### NUCLEAR REGULATORY COMMISSION

MEMORANDUM FOR: Docket File No. WM-48

SUBJECT: SUPPLEMENTAL STANDARDS APPLICATION FOR SLOPES OF SMELTER MOUNTAIN AT THE DURANGO PROCESSING SITE (RAP MODIFICATION #2)

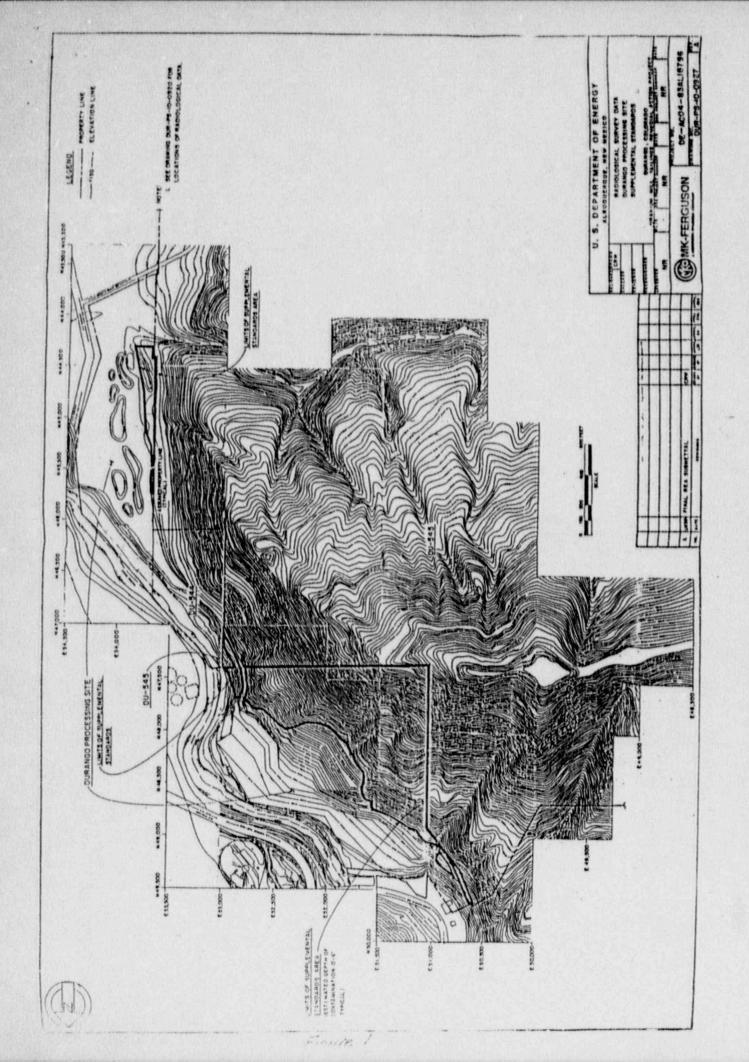
During a site visit conducted September 6, 1989, the proposed area was observed and the proposal discussed with DOE and the State of Colorado. The two areas identified are located (1) on the slopes of Smelter Mountain above the footprints of the old tailings piles and the tailings pile access roads, with a small area just to the south of the old tailings piles, between the UMTRA haul road and the Animas River, and (2) on the slope of Smelter Mountain above the UMTRAP haul road, just above the area of the raffinate ponds. These areas are shown on Figure 1.

The DOE report concluded that supplemental standards should be applied to the 308,958 square yards delineated on Figure 1. They describe the area as "sporadically contaminated in the top 6 inches of soil with steep, washed areas at or near background Ra-226 concentrations while more level and vegetated areas have higher activity."

NRC review indicates that the data presented supports the DOE conclusion.

Therefore, the staff recommends approval of supplemental standards for the area requested.
